**Docket Item #19
Potomac Yard - Landbay K
DSUP2006-0013**

Docket Item #20
Dev. Special Use Permit #2006-0013
Potomac Yard Park – Landbay K

REQUEST: Consideration of approval for a 24 acre park, within Potomac Yard development.

17. Promenade construction

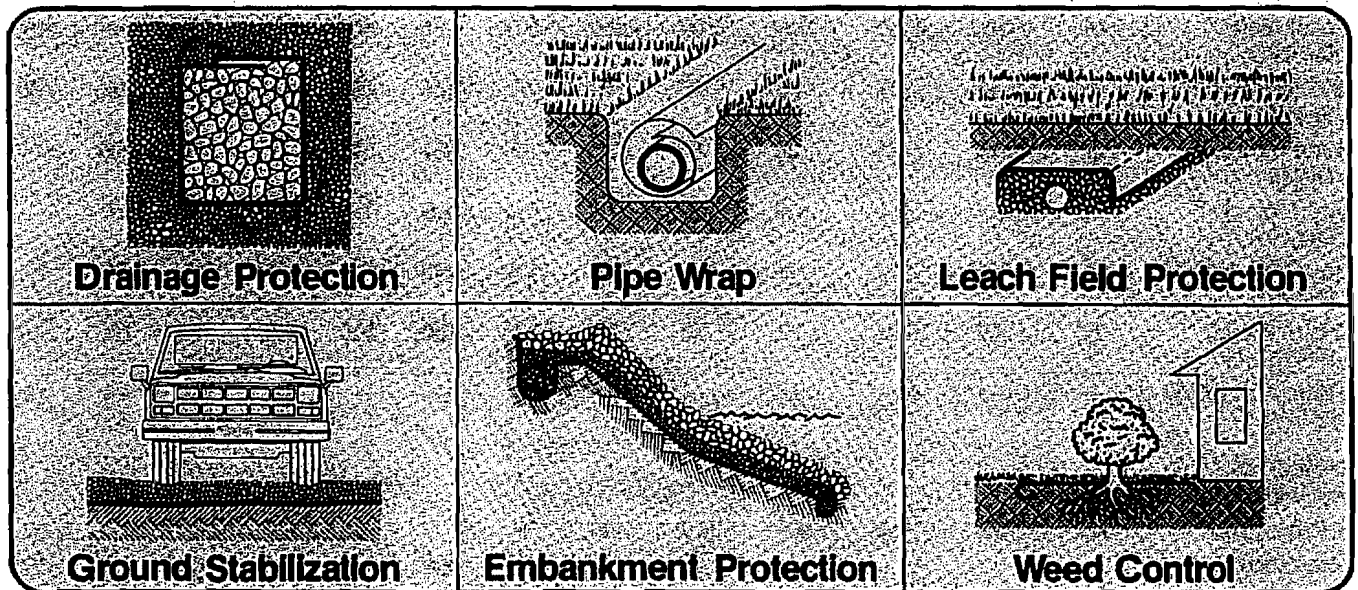
The promenade will be constructed to maintain an H20 loading capacity, with asphalt pavers as the top course. The base construction and materials will be engineered through the Final Site Plan process.
